32	2024.04.10	ISSUED FOR SH13r1
29	2024.03.25	ISSUED FOR SI21
25	2024.02.13	ISSUED FOR SH13
17	2023.12.10	ISSUED FOR SI06
13	2023.10.20	ISSUED FOR CONSTRUCTION
12	2023.10.12	ISSUED FOR REVIEW
10	2023.08.16	ISSUED FOR 75% REVIEW
5	2023.05.29	ISSUED FOR PERMIT
4	2023.04.14	ISSUED FOR 33% REVIEW

**WINONA PH
DEVELOPMENT**

**EXTERIOR
ELEVATIONS**

3 NORTHEAST CORNER VIEW

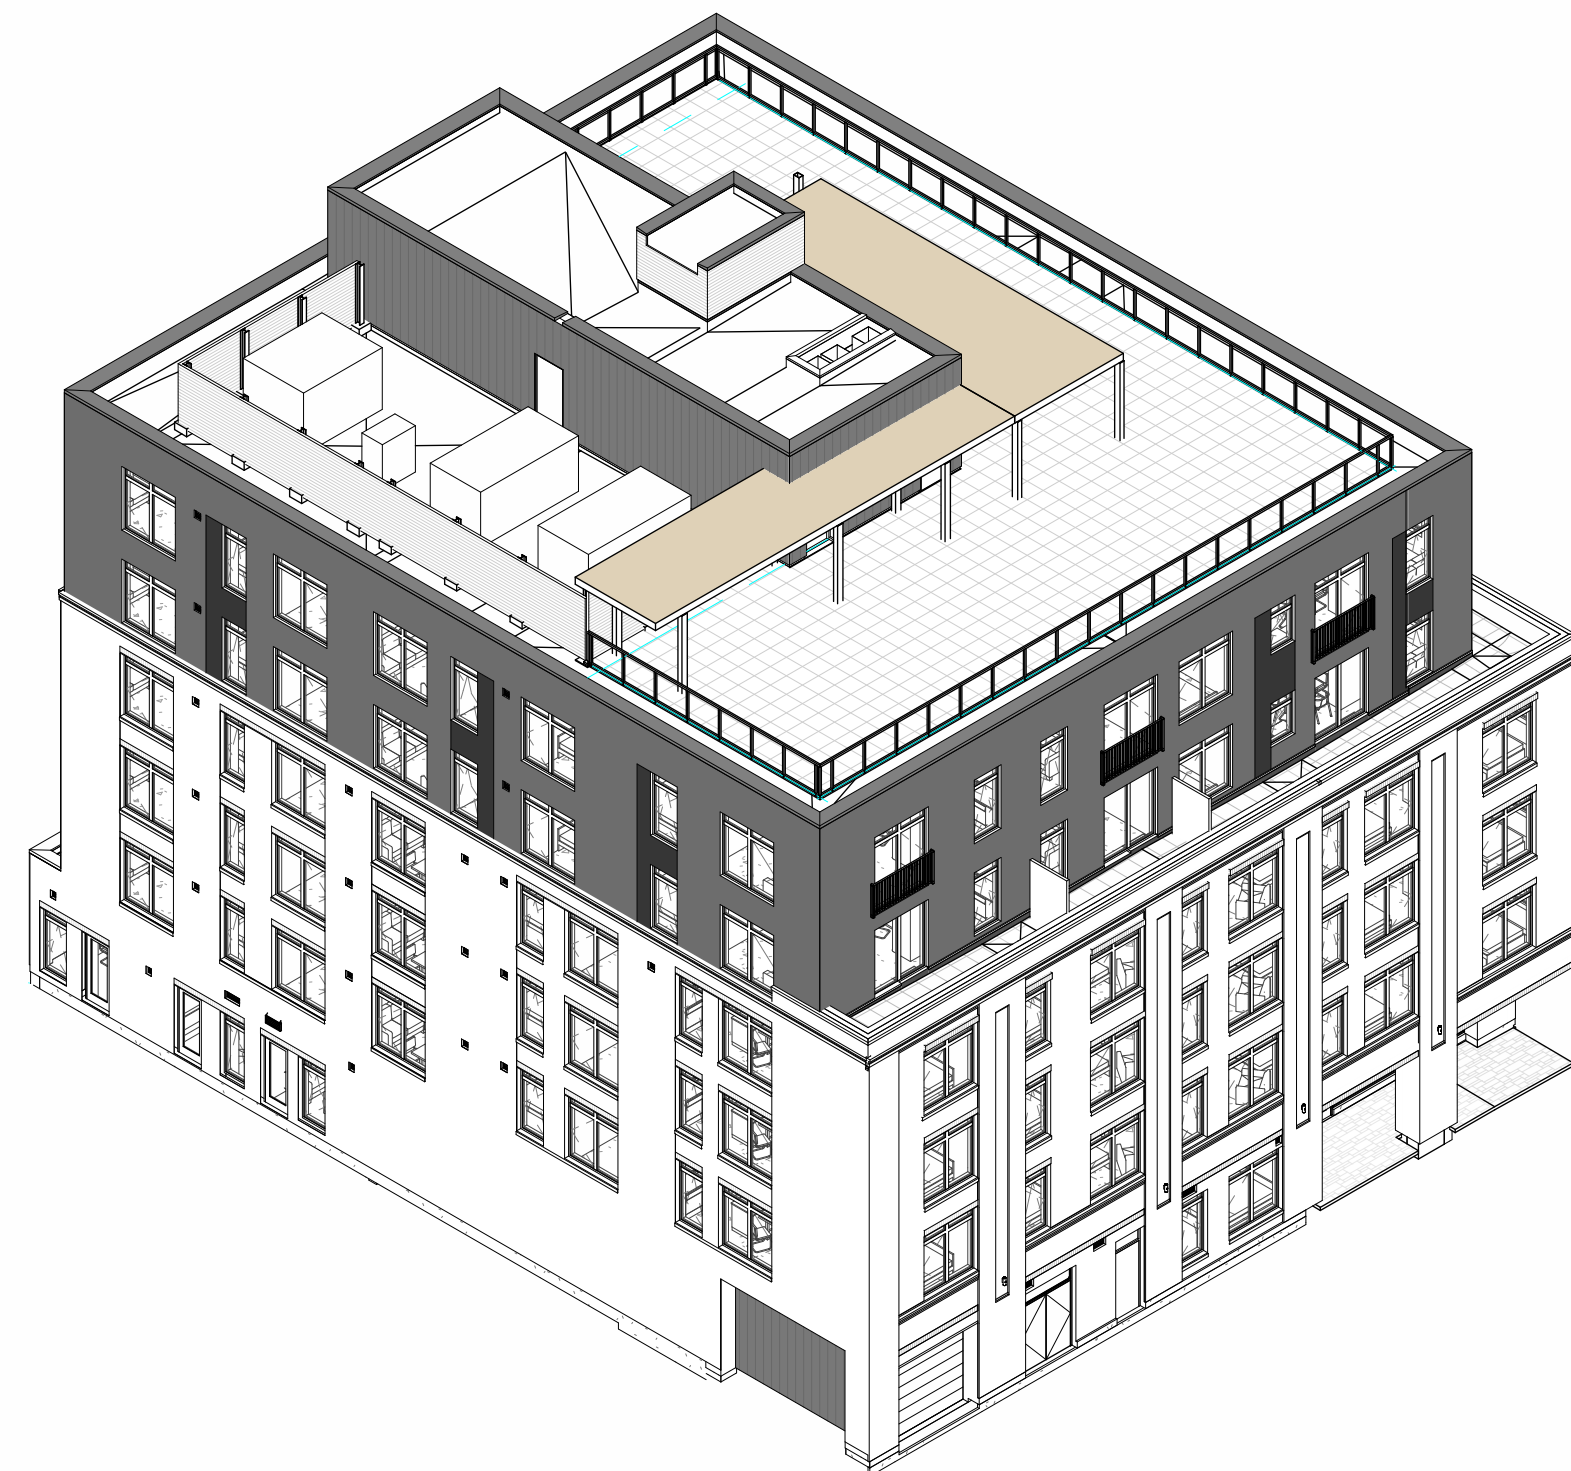
PROPOSED CHANGES IN ROOFTOP AMMENITY SPACE:
EXISTING AMMENITY AREA: 315.5 m²
NEW AMMENITY AREA: 67.5 m²
TOTAL AMMENITY AREA: 383 m²

3 SOUTHWEST CORNER VIEW
A301r2

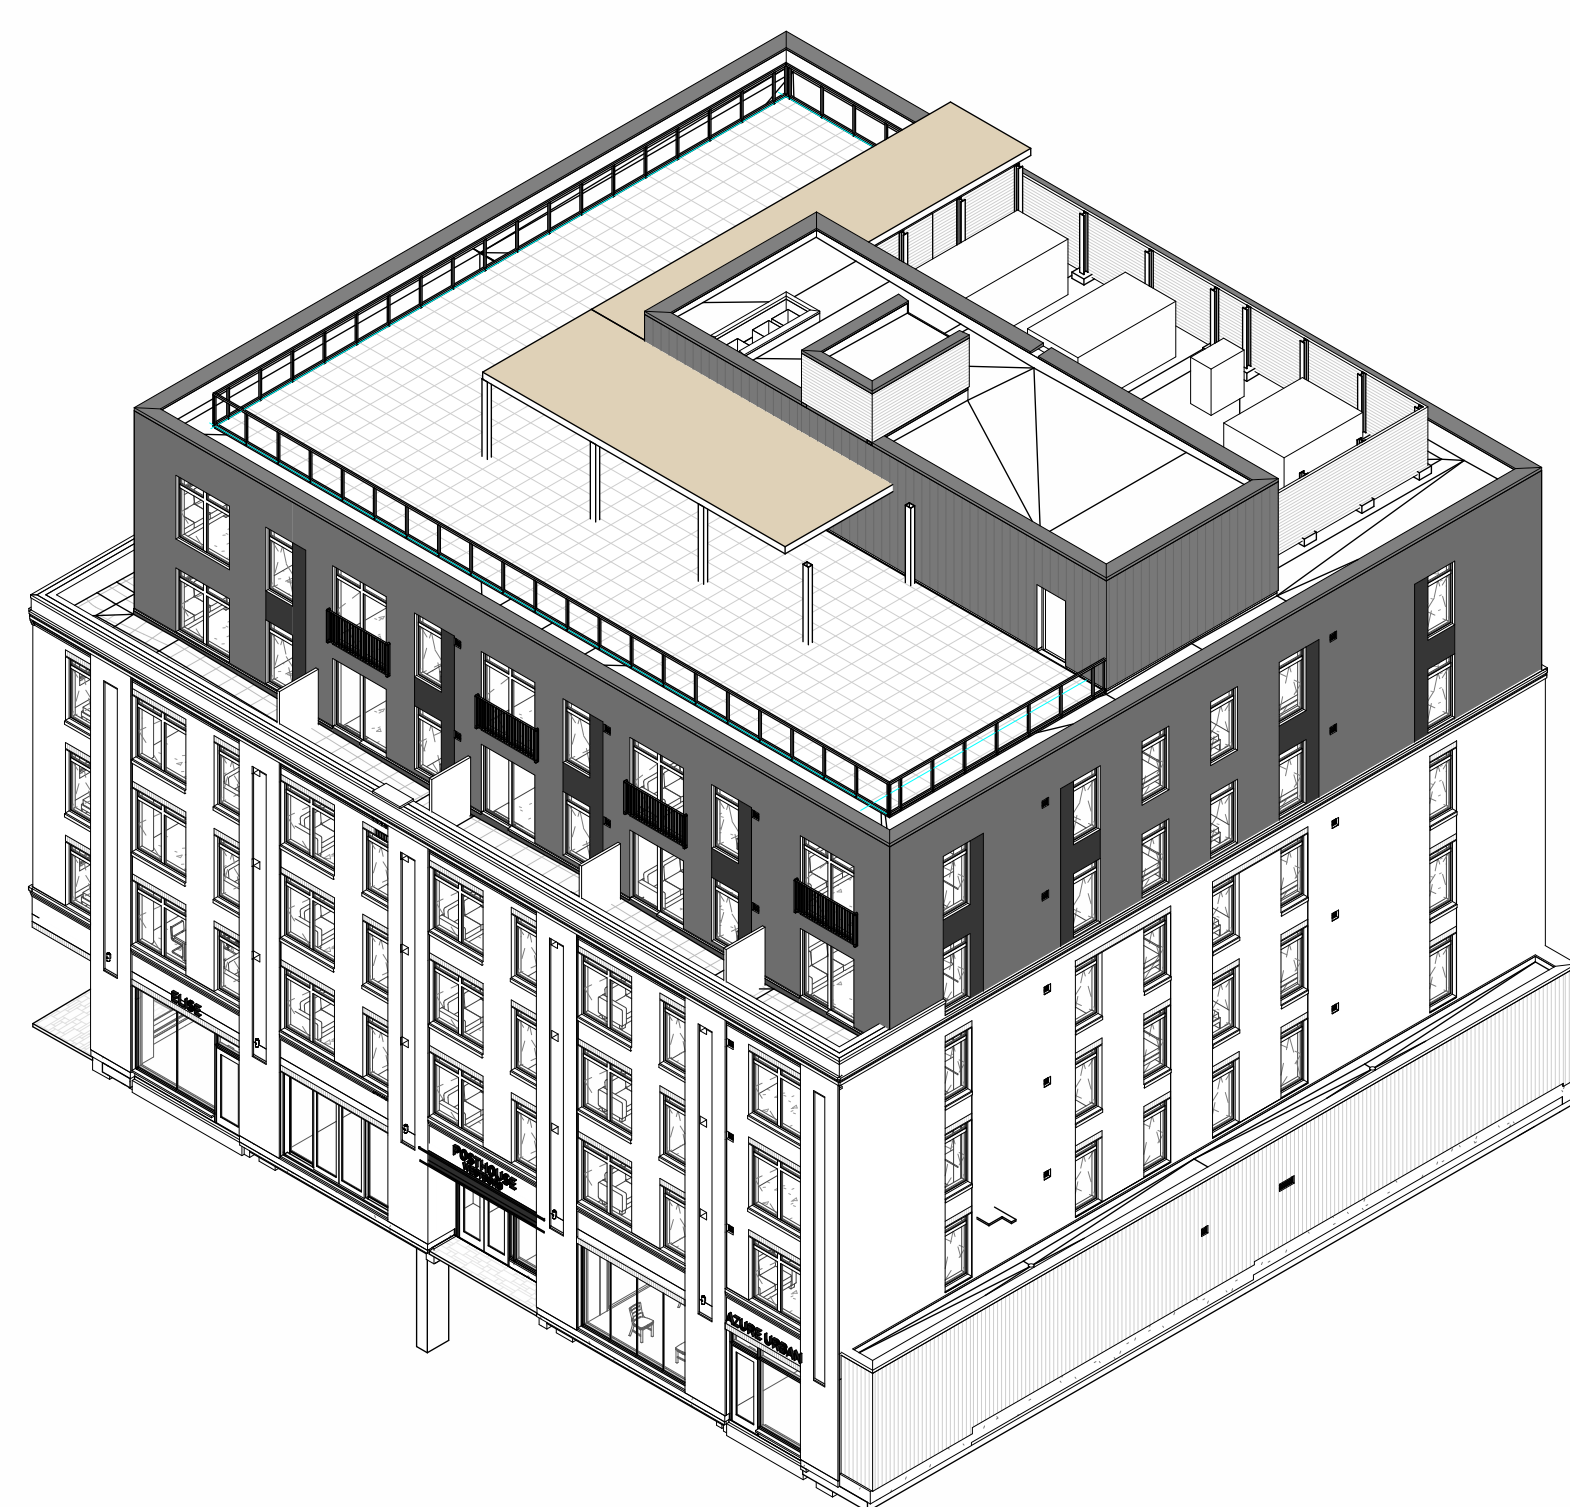
PROPOSED CHANGES IN ROOFTOP AMMENITY SPACE:
EXISTING AMMENITY AREA: 315.5 m²
NEW AMMENITY AREA: 67.5 m²
TOTAL AMMENITY AREA: 383 m²
